28

weekly notice

Monday, 07 July 2025

RailSafe

VER 18062025
DIAGRAM VER 16042025

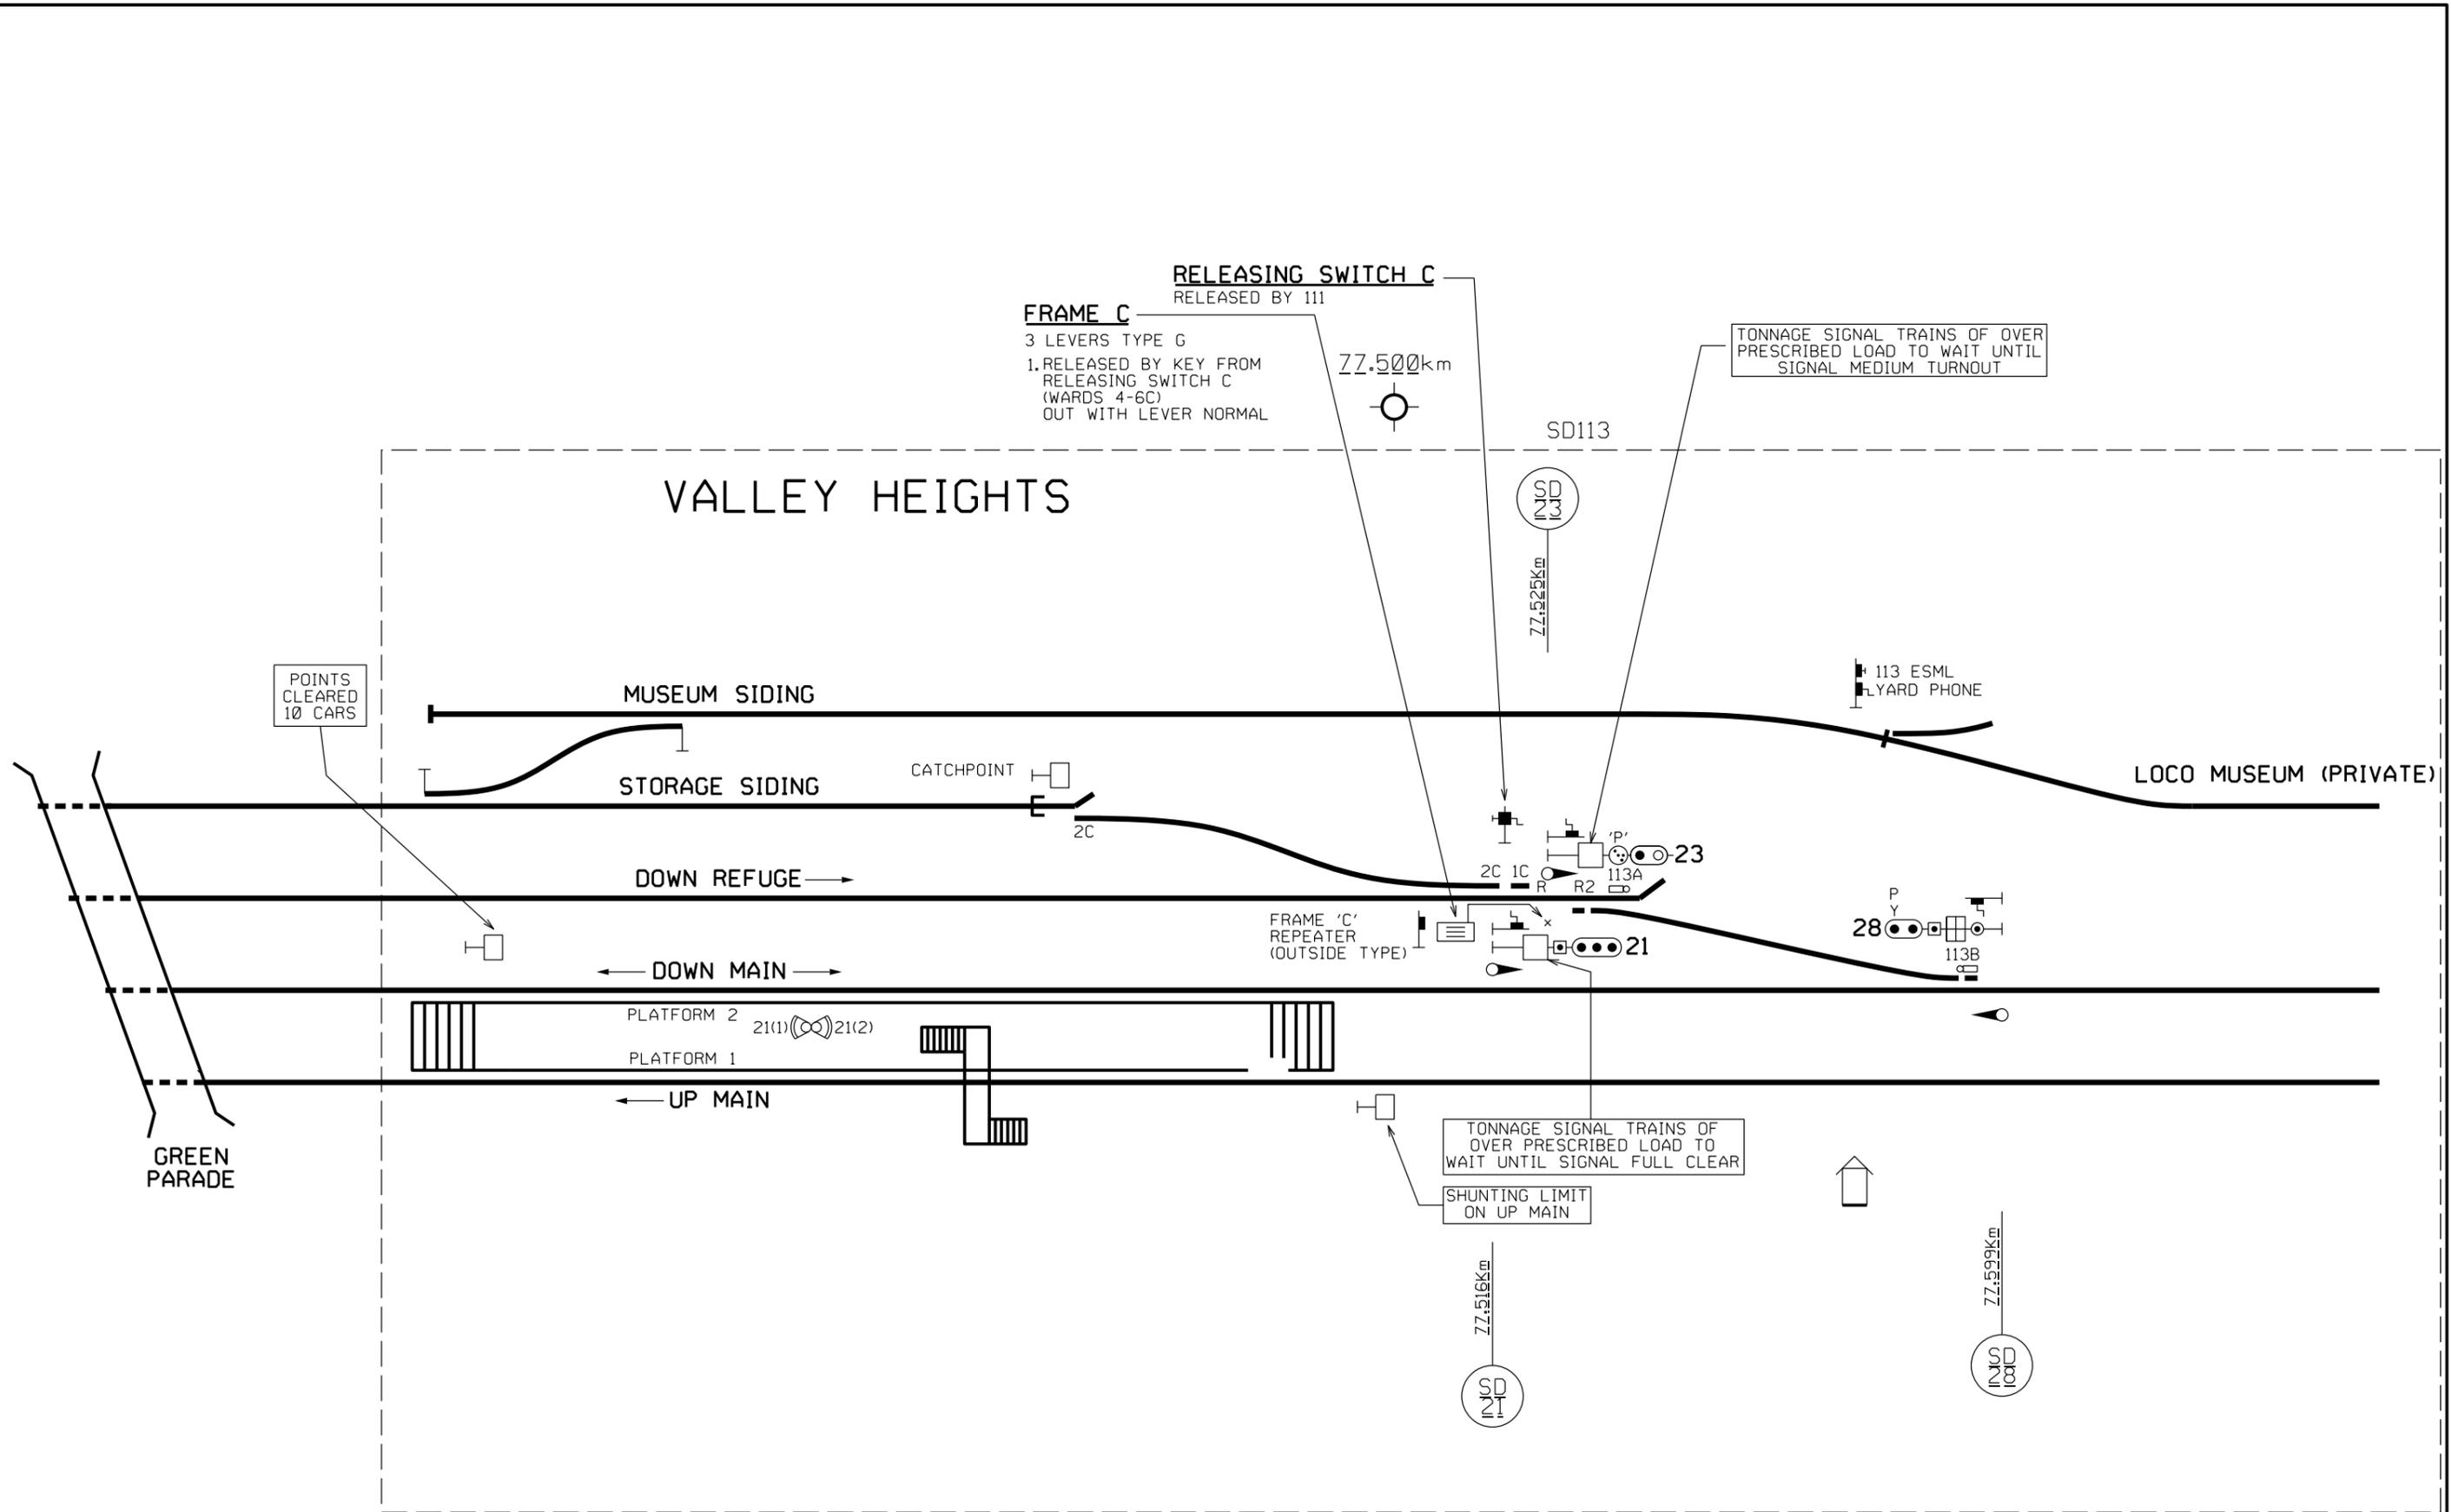
- Removal of the white Cross and Commissioning of the new “POINTS CLEARED 10 CARS” post mounted sign on the DOWN MAIN (within VALLEY HEIGHTS, PLATFORM 2 limits) at approx. 77.331km as indicated in the Driver’s Diagram in this Since Notice.

- Car marker changes as listed in table 02 below.
- Commissioning of the new platform car marker & trackside stopping sign arrangements at the Valley Heights, Glenbrook and Blaxland stations to accommodate the new 4,6,8 and 10 car NIF trains as listed in Tables 1 & 2 below.

Diagram 1: Penrith Car Marker Changes**VER 18062025****Matthew Ward**

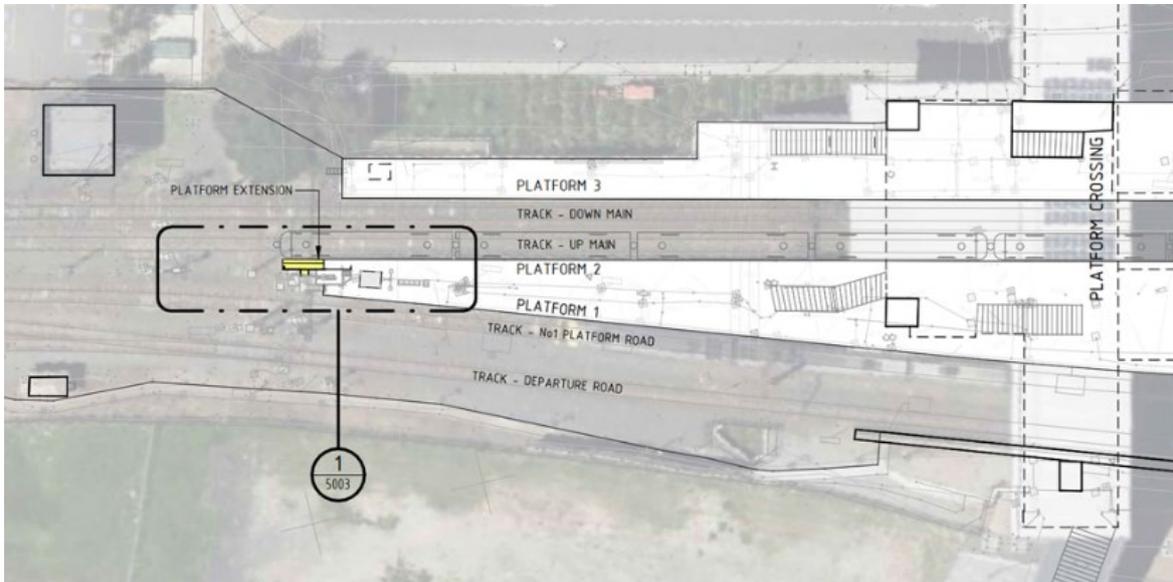
- Construction of a temporary Mariyung Train Guards use only platform extension at the city end of platform 2 at Penrith. Refer to diagram 1 below for details.
- This will be in use until a permanent platform extension is completed in a later stage.
- Installation of a “10” Carmarker sign with a white cross on the new fenceline for the extended temporary platform.

- Removal of the existing Penrith Platform 2 City End “Points Cleared 10 Cars” sign.

- Commissioning of the new platform car marker & trackside stopping sign arrangements at Penrith to accommodate the new 4,6,8 and 10 car NIF trains. Listed in table 1 below.

Station	Platform	Carmarker changes
Penrith	1 Sydney End	Existing “8” carmarker sign on the fence and '8' carmarker on the coping will be removed and replaced with new '8' carmarker on coping approx. 2.1m from the fence.
Penrith	1 Country End	Existing '8' carmarker on the coping will be removed and replaced with New '8' carmarker on coping at approx. 2.8m from the fence.
Penrith	2 Country End	New '10' carmarker sign on the new fenceline position for the extended temporary platform.
